1. Residential Design/Development Review: Canyon Springs Estates Lot 21, Sean and Ann Keightley

To: Planning Commission
From: Thomas Dansie, Director of Community Development
Date: August 13, 2020
Re: August 19, 2020 Town Council Meeting
Residential Design / Development Review – Canyon Springs, Lot 21

KEIGHTLY RESIDENCE

ELECTRICAL PLAN
 SCALE: 1/4" = 1'-0"

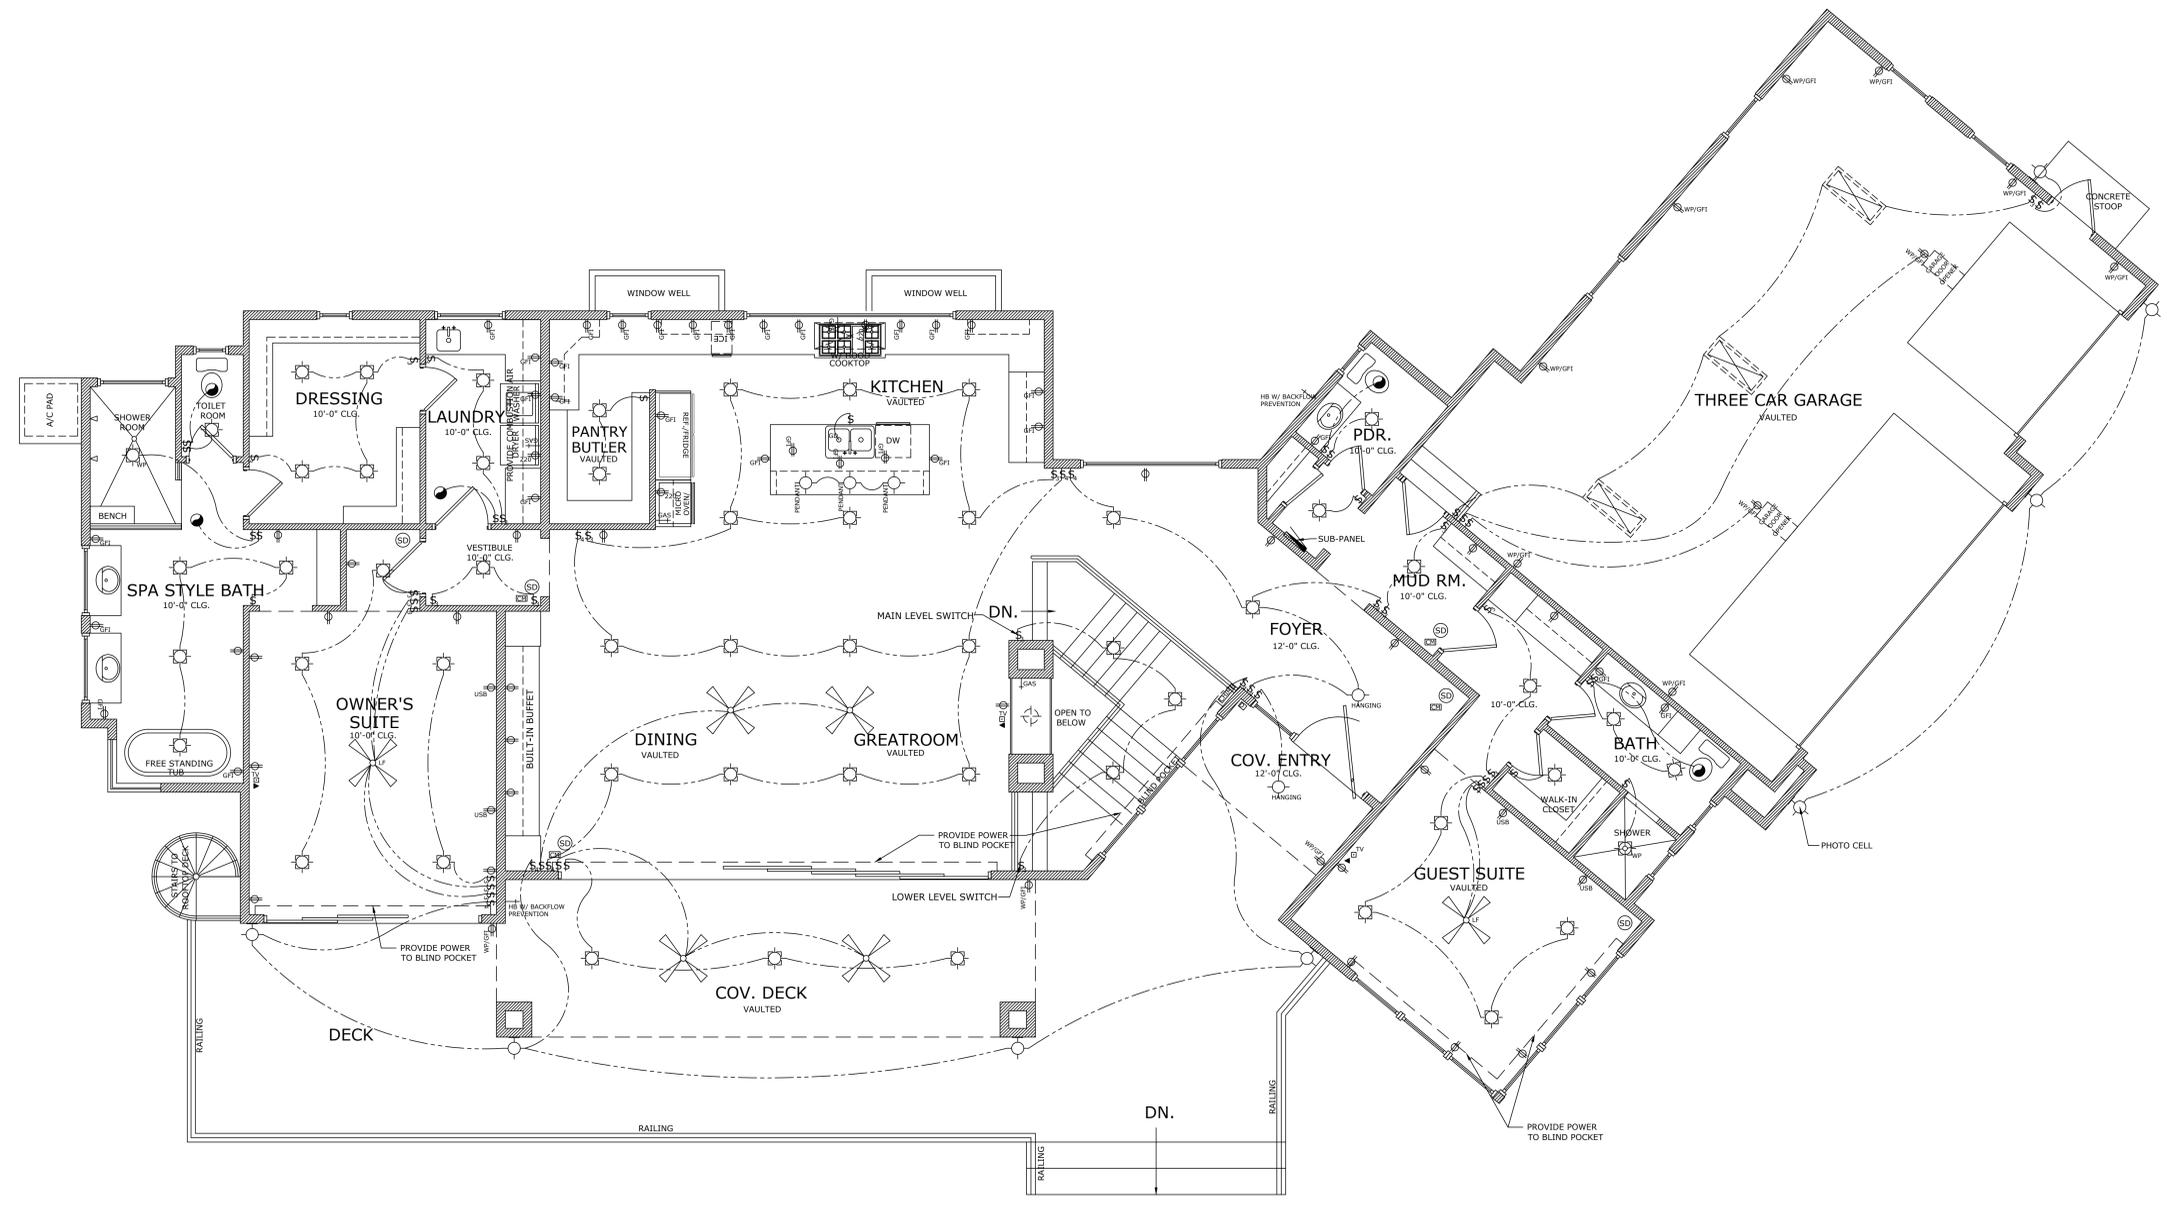
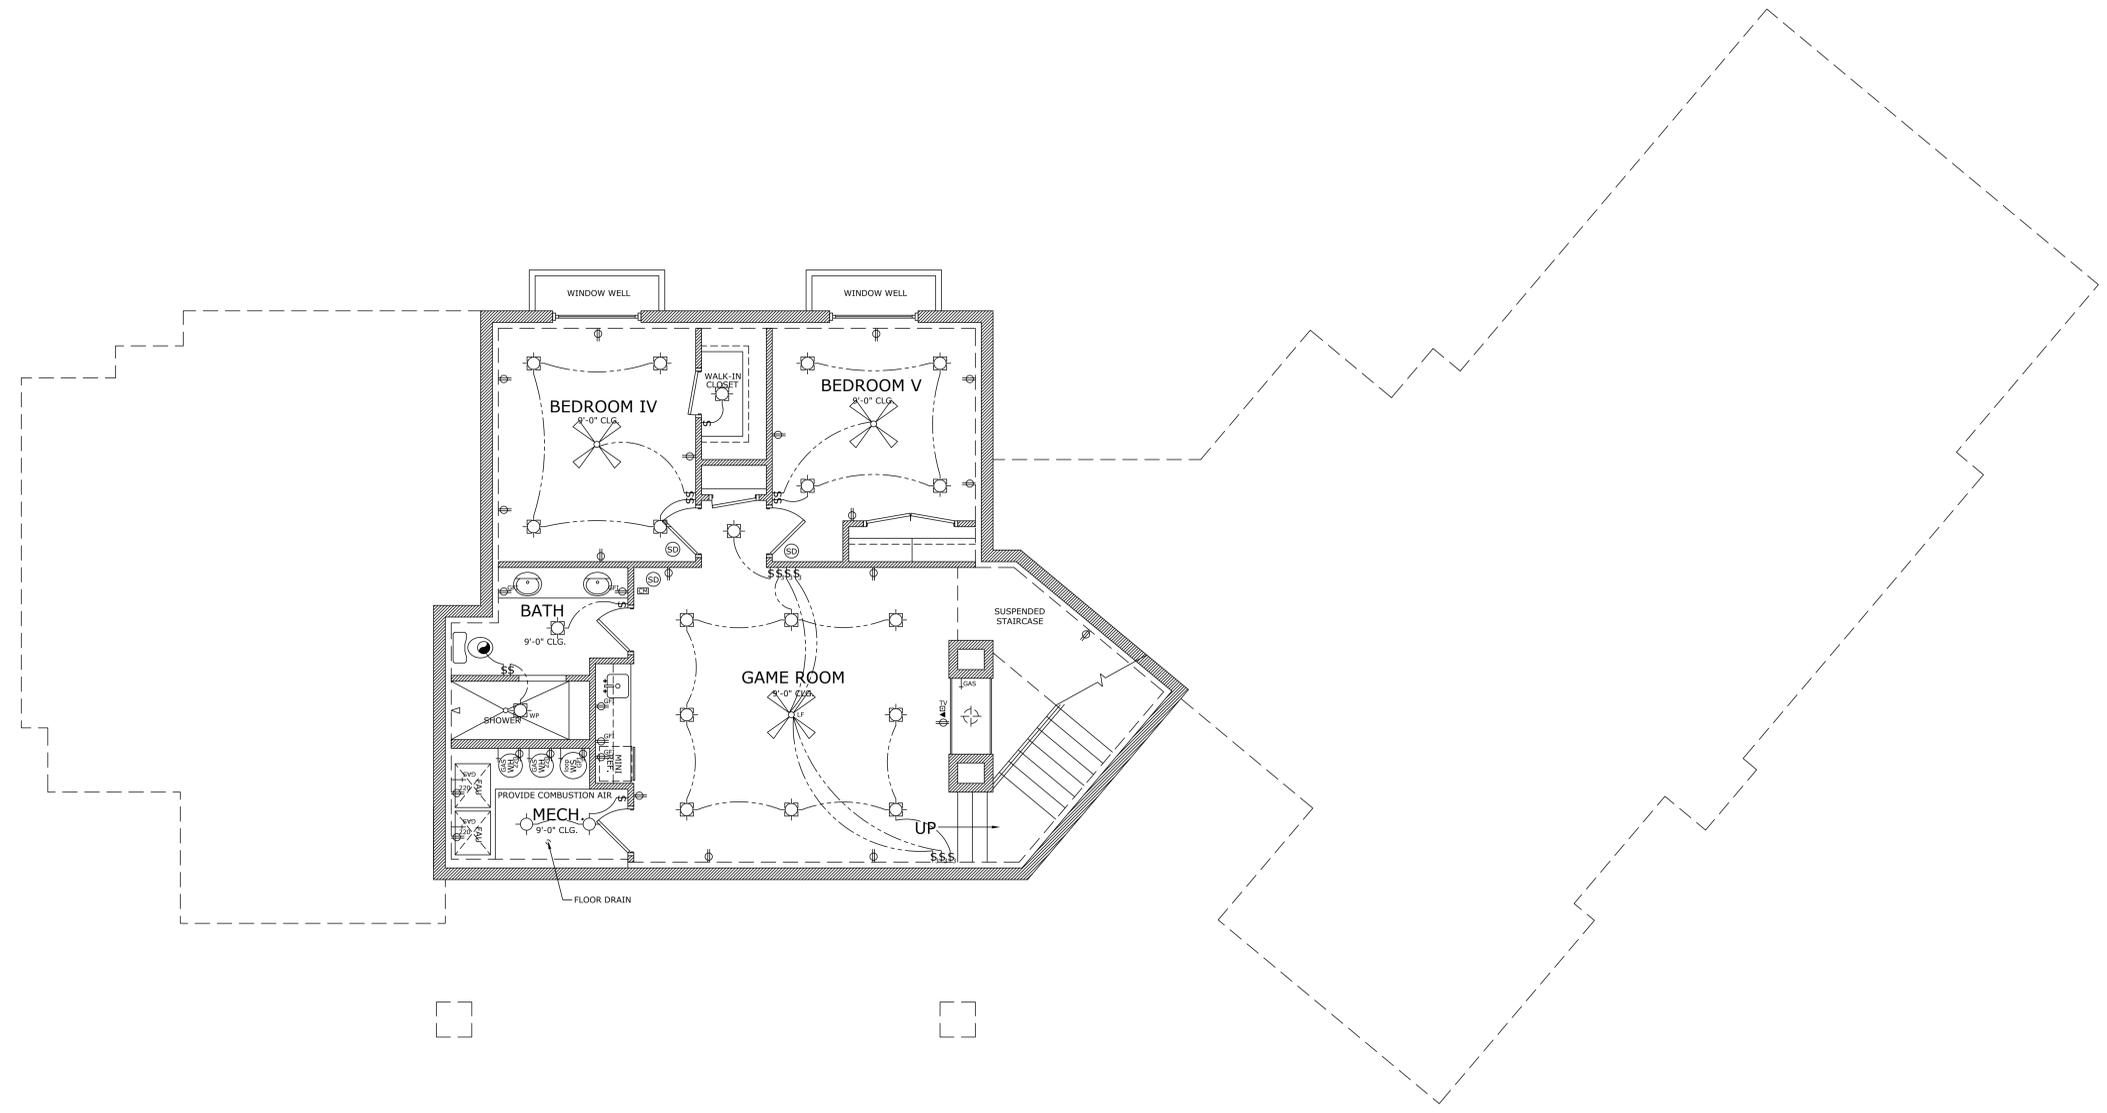
The package includes electrical plans (Pages 19 and 20, labeled E-1 and E-1.1) for the Main Level and Lower Level. However, there is no indication of any electrical fixtures (outlets or lights) on the Roof Top Deck. I would like to see the commission get confirmation of the lack of electrical fixtures on the Roof Top Deck, and include that there shall be NO light fixtures installed on Roof

Top Deck as a condition of approval.

Also pertaining to lighting: Page 19 of the package, E-1 Main Level Electrical indicates a photo cell will be mounted for the 3 exterior light fixture on the garage. This implies that these lights will be on from dusk to dawn, 7 days a week, all year long. As this home is less than 150 feet from the boundary with Zion National Park, and is a common thoroughfare for wildlife including deer, fox, and mountain lion, I would like the commission to consider not approving a photo-cell installation on these exterior lights due to the detrimental effect on nocturnal animals. It seems that this action is allowed by Chapter 10-15C Outdoor Lighting Ordinance that states as its purpose in Section 10-15C-1(F) "To minimize nighttime impacts on nocturnal wildlife."
